Model: Model AI-C1	Date: 07-Nov-07	No.: RD009001j
---------------------------	-----------------	----------------

Subject: Firmware Release Note: NetworkDocBox		Prepared by: T. Hirakawa	
From: 2nd Tech Service Sect., MFP/Printer Tech Service Dept.			
Classification:	<input type="checkbox"/> Troubleshooting	<input type="checkbox"/> Part information	<input type="checkbox"/> Action required
	<input type="checkbox"/> Mechanical	<input type="checkbox"/> Electrical	<input type="checkbox"/> Service manual revision
	<input type="checkbox"/> Paper path	<input type="checkbox"/> Transmit/receive	<input type="checkbox"/> Retrofit information
	<input type="checkbox"/> Product Safety	<input checked="" type="checkbox"/> Other ()	<input checked="" type="checkbox"/> Tier 2

This RTB has been issued to announce the firmware release information for the **Network DocBox**.

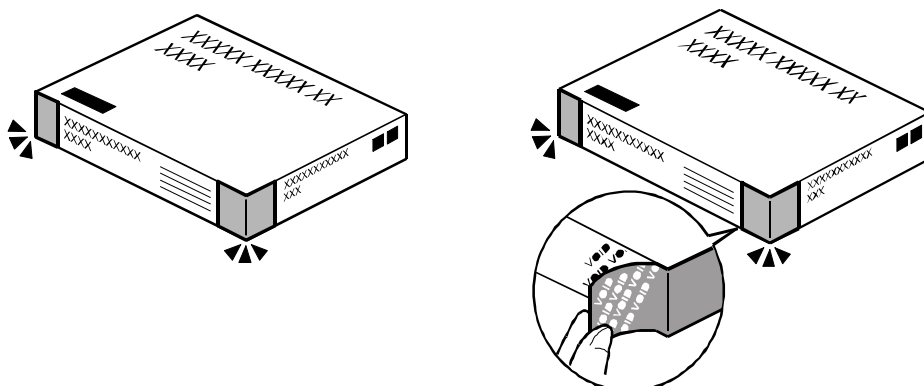
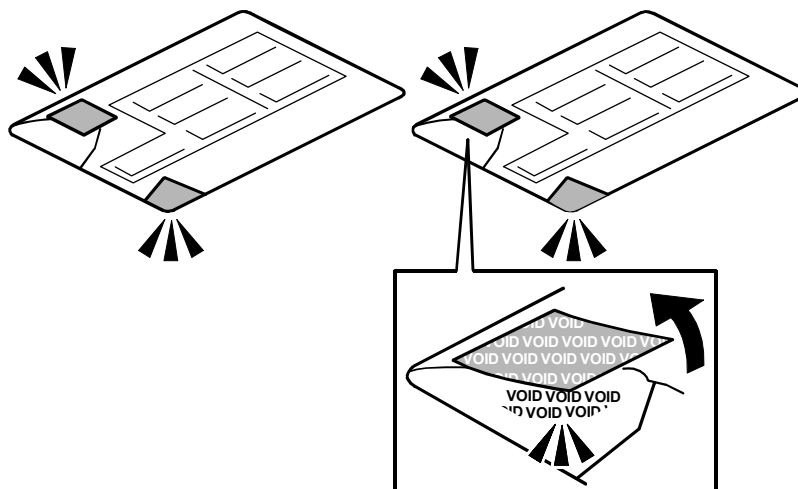
The illustration of the package has been corrected.

Incorrect:

Correct:

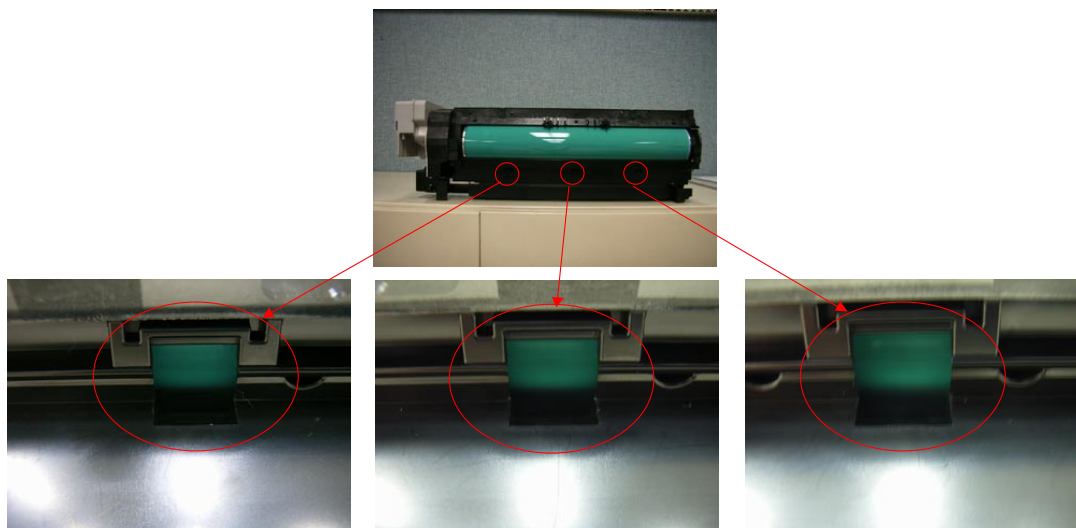
Three caps were added to the areas shown below.

New P/N for the development unit: **D0092301**

P/N for the caps: **D0093102**

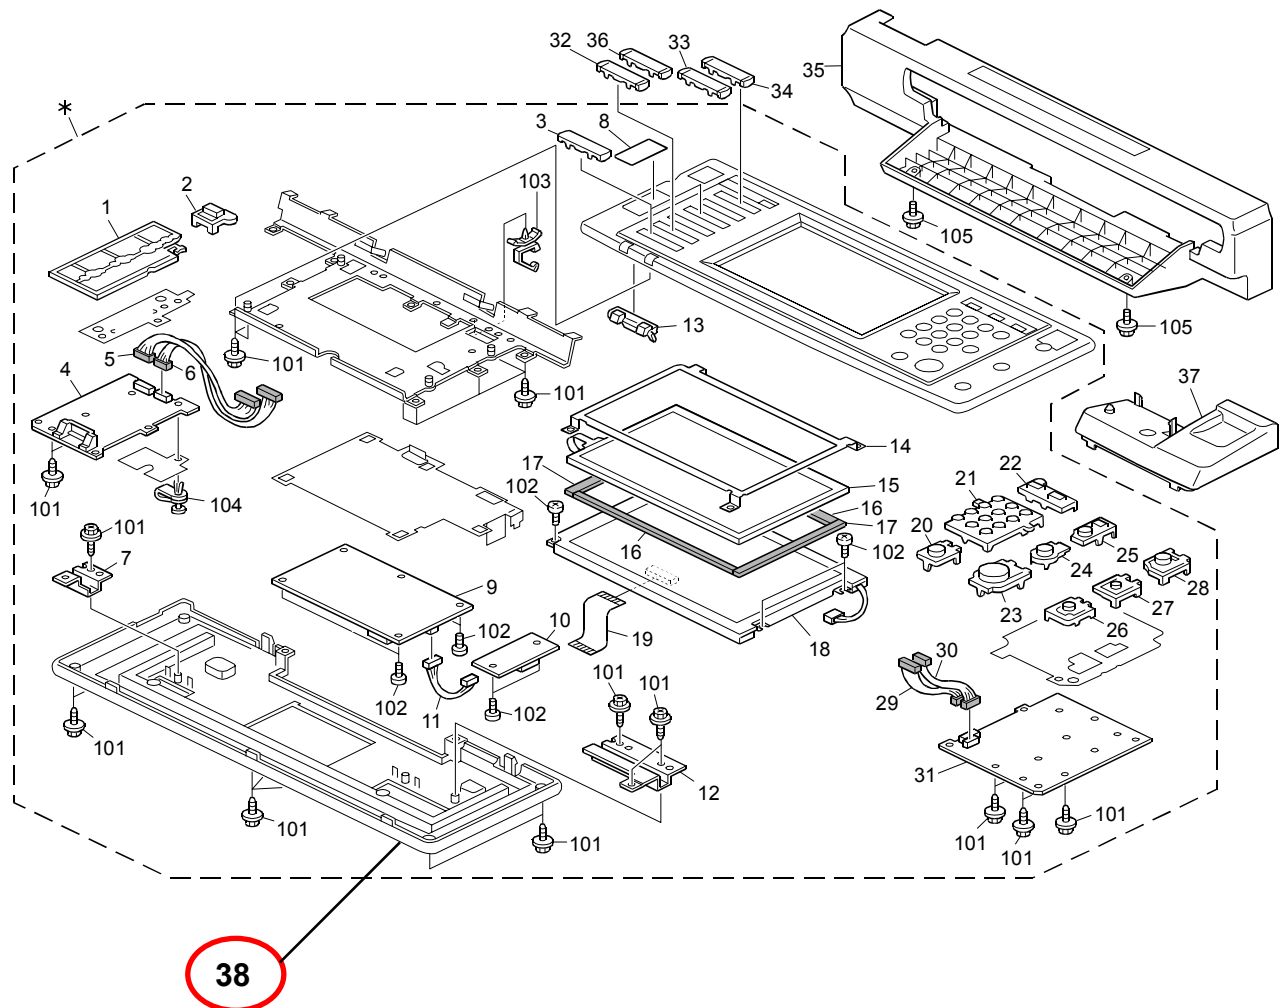
Change: The part in the table was added.

Reason: To meet requests received from the field.

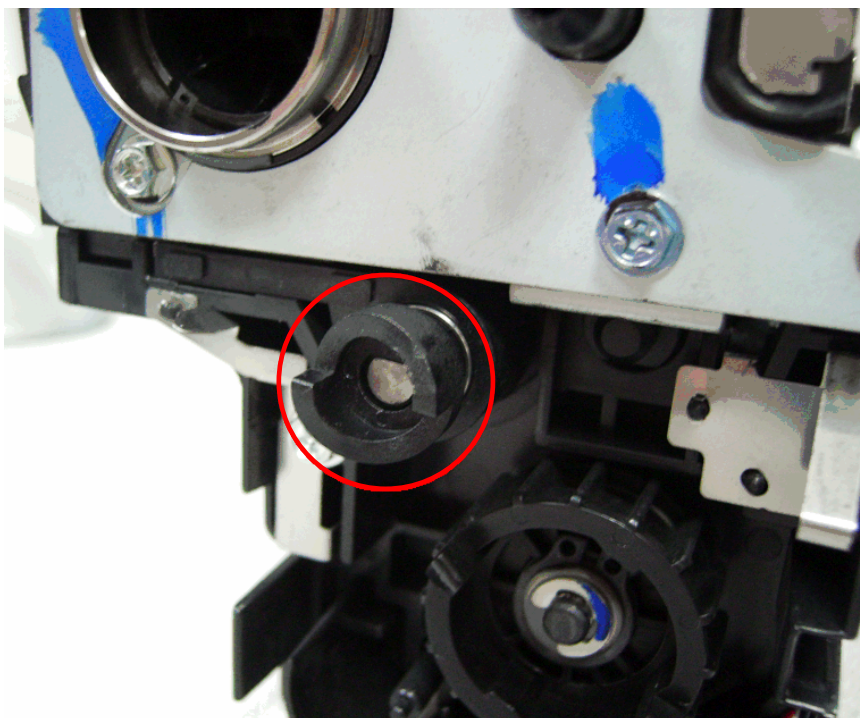
Change: The part in the table was added.

Reason: To meet requests received from the field.

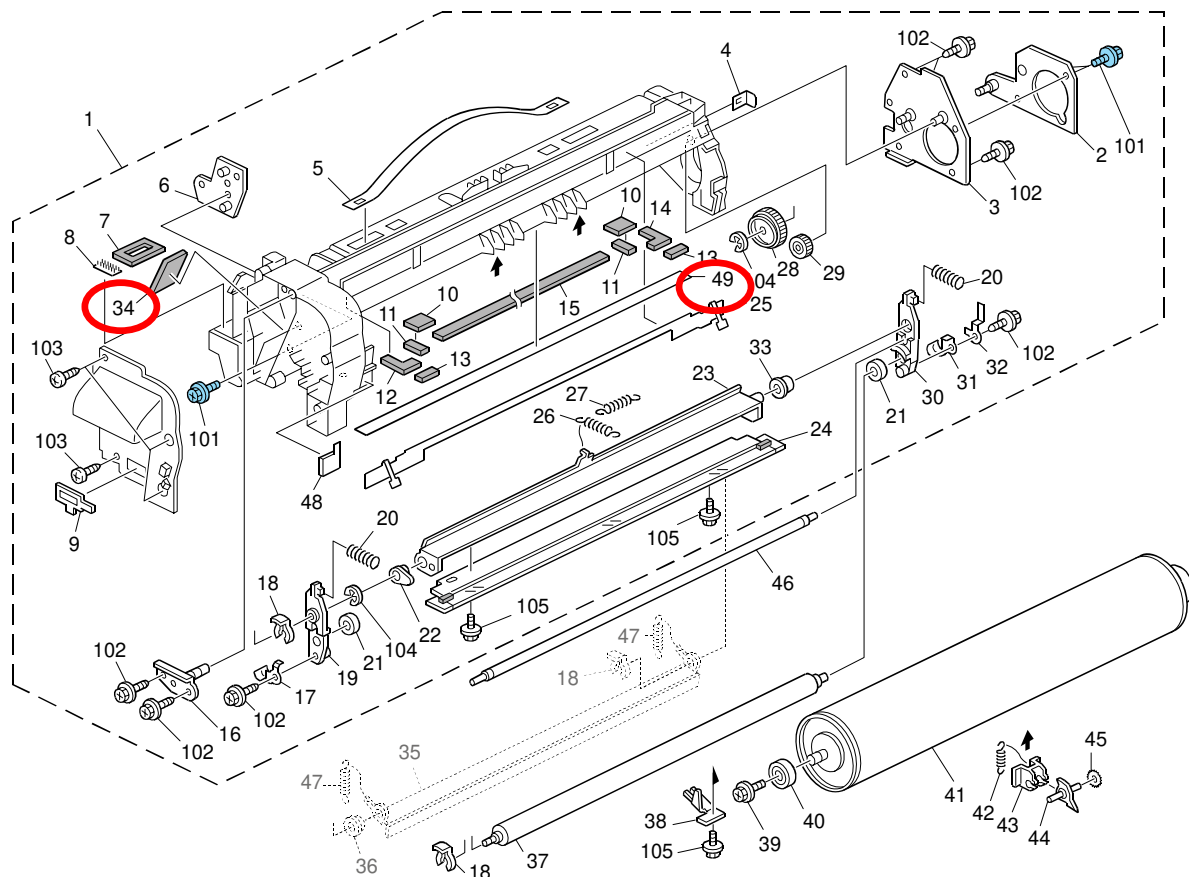
- 1) The part shown in the table was added.
- 2) Index #34(D0092426: Seal-24.5x68.5) was added to the illustration.

Reason: This information was missing from the Parts Catalog.

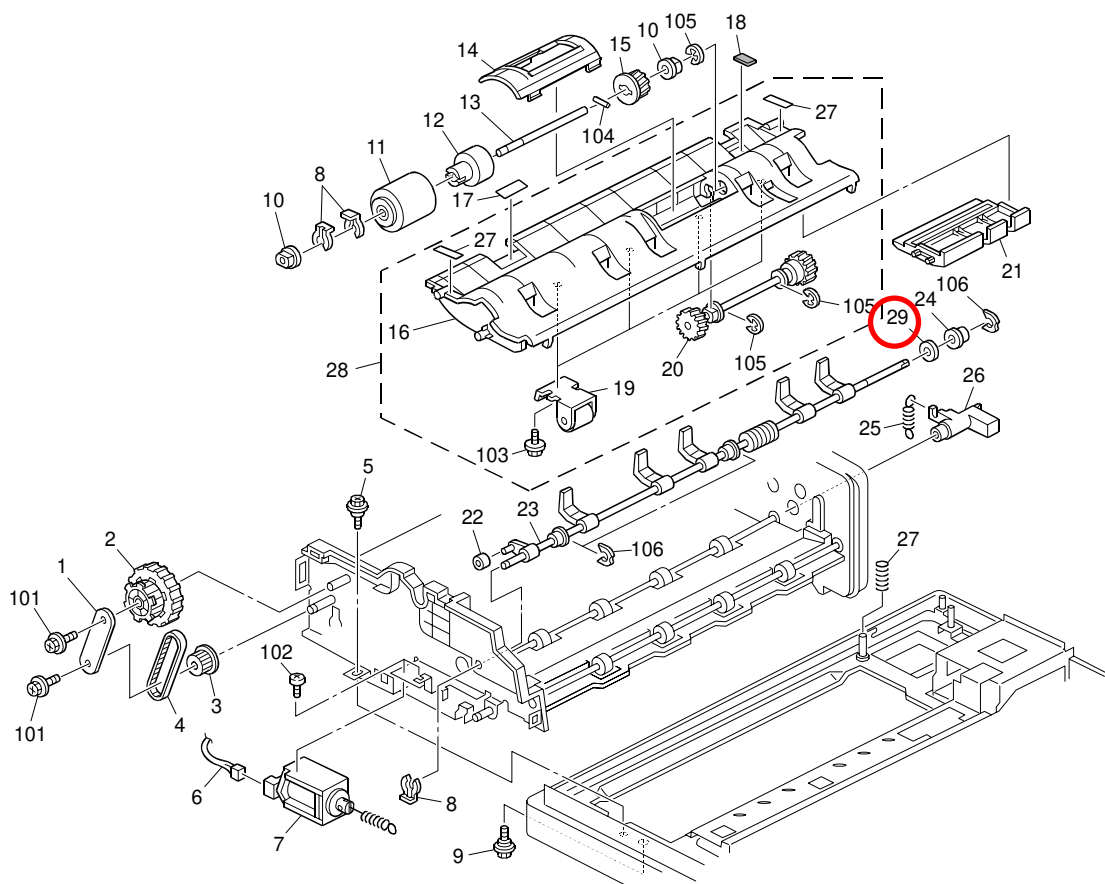
Change: The part in the table was added.

Reason: To further improve the movement of the guide (B8022226).

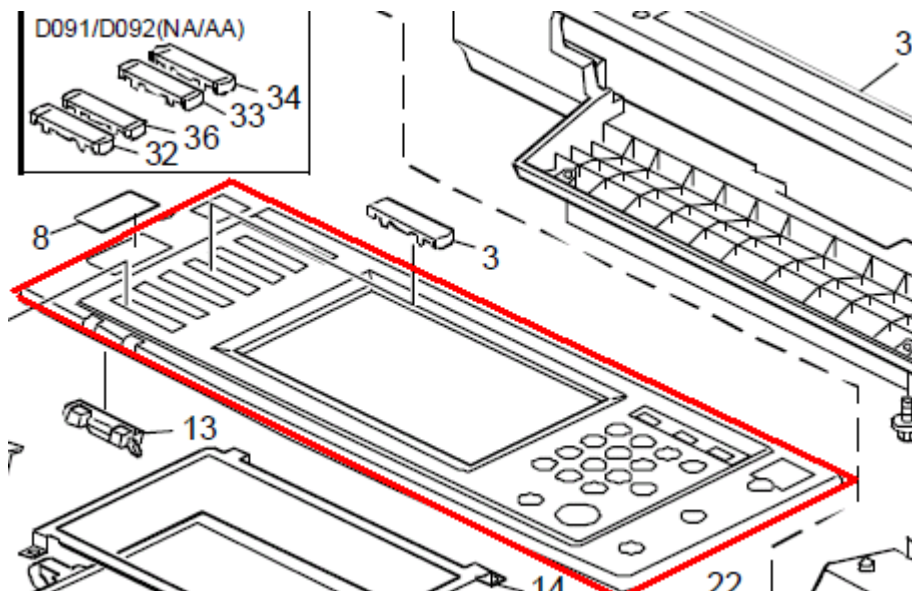
Change/Reason:

As per field request, the following part was newly added as a service part.

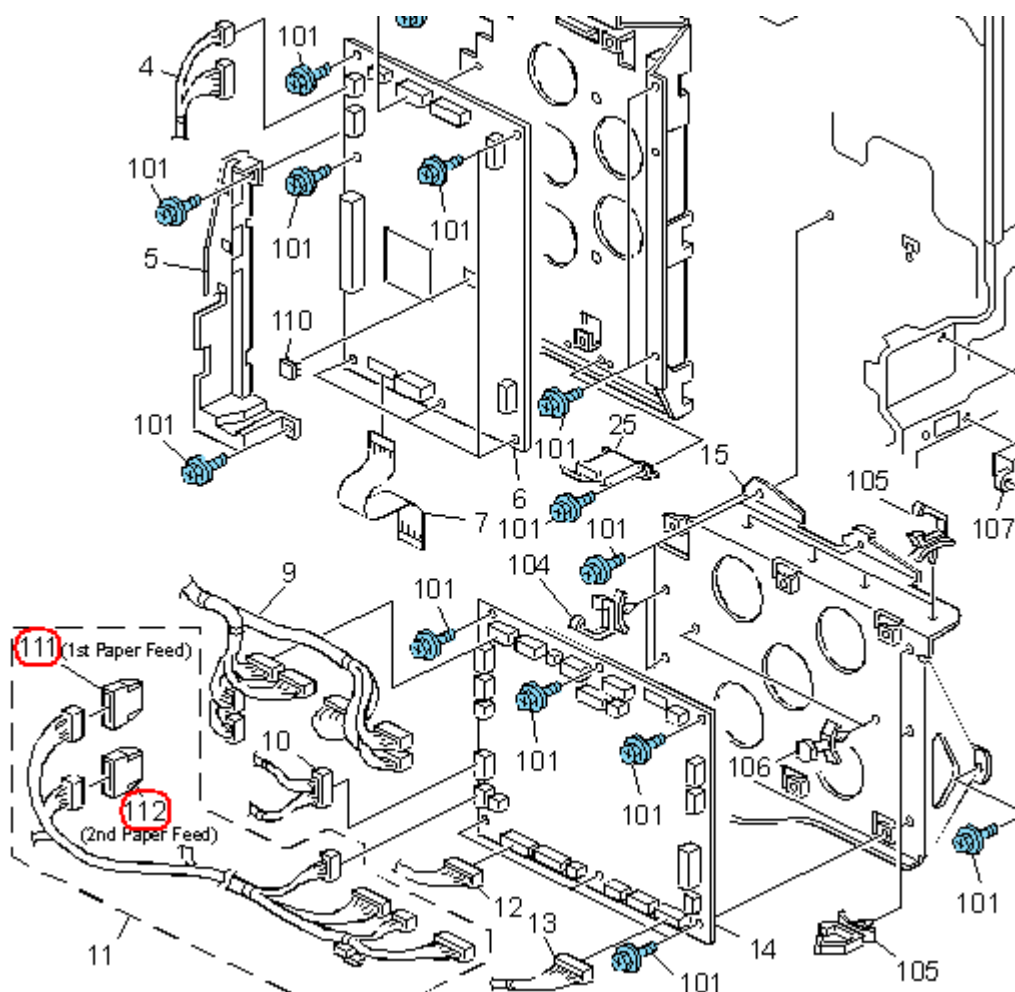
Change/Reason:

As per field request, these parts were newly added as service parts.

Pg. 62

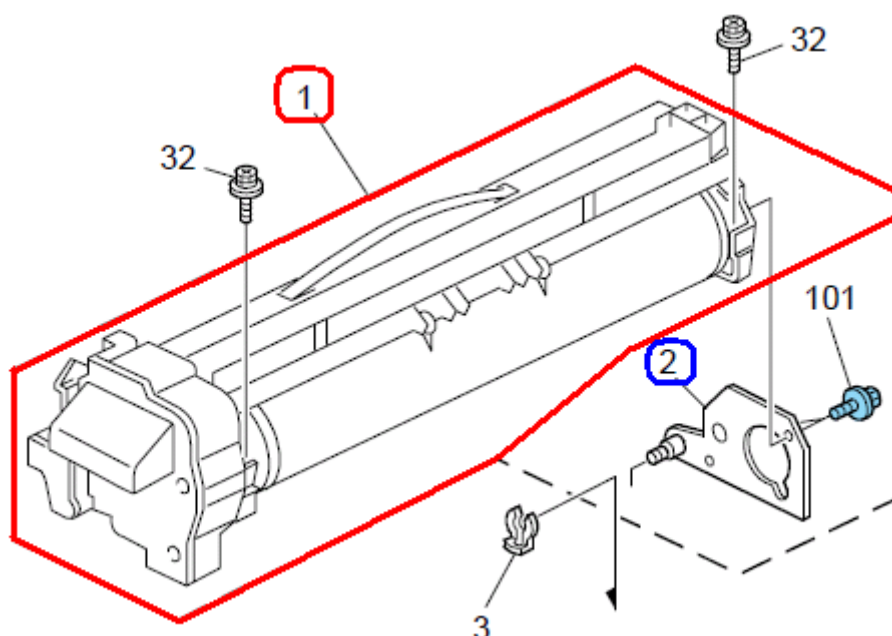
- The area enclosed by the red box is the correct outline for P/N D0092105 (index #1).
- The rear side plate (index #2) is registered separately as an individual service part.

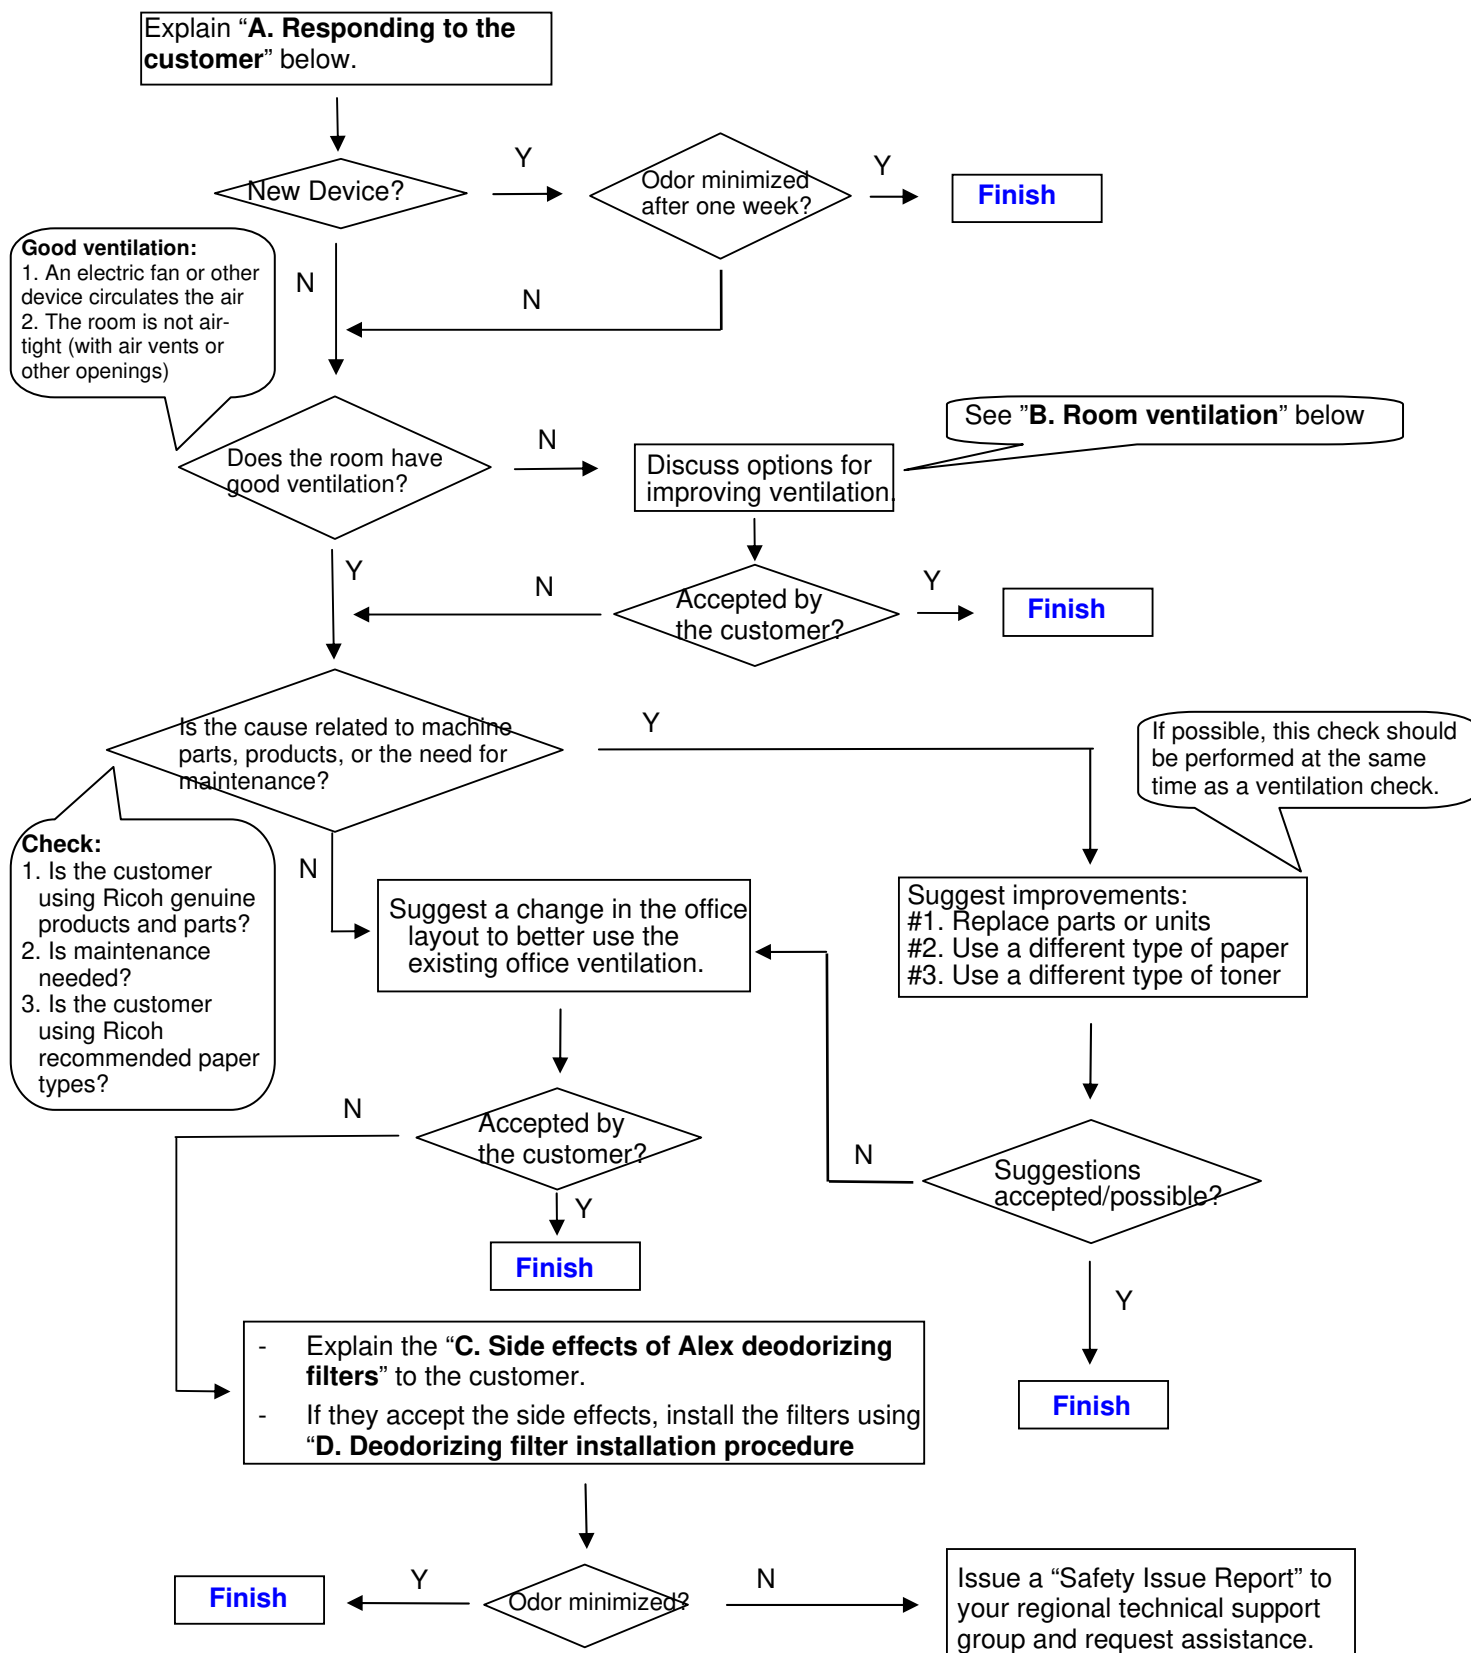
Change: Deodorizing filters were newly added as service parts for the AL-C1/AL-C1.5/AL-C2/AL-P1.

Reason: To meet the requests of customers who may report strange odors on these models.

9.Original Transfer 2 (D009/D011/D012/D013)

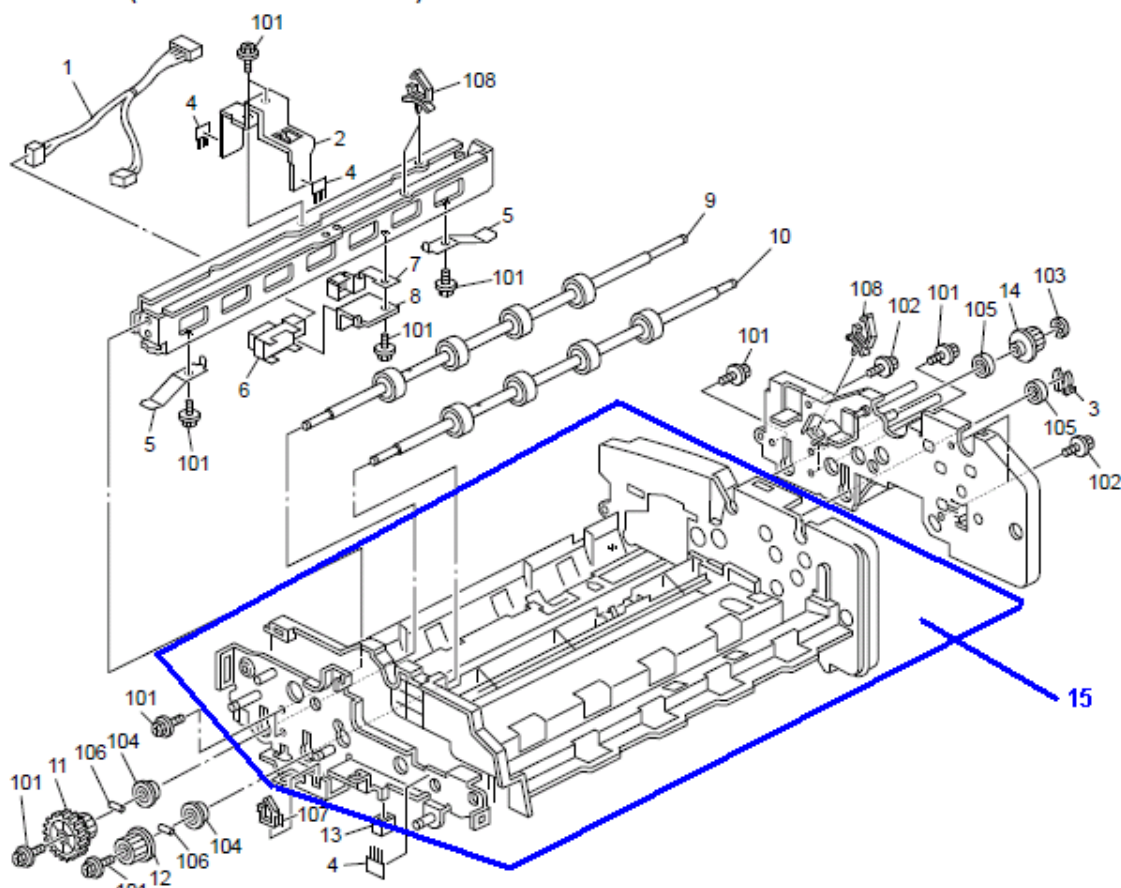
As per field request, the following part was newly added as a service part.
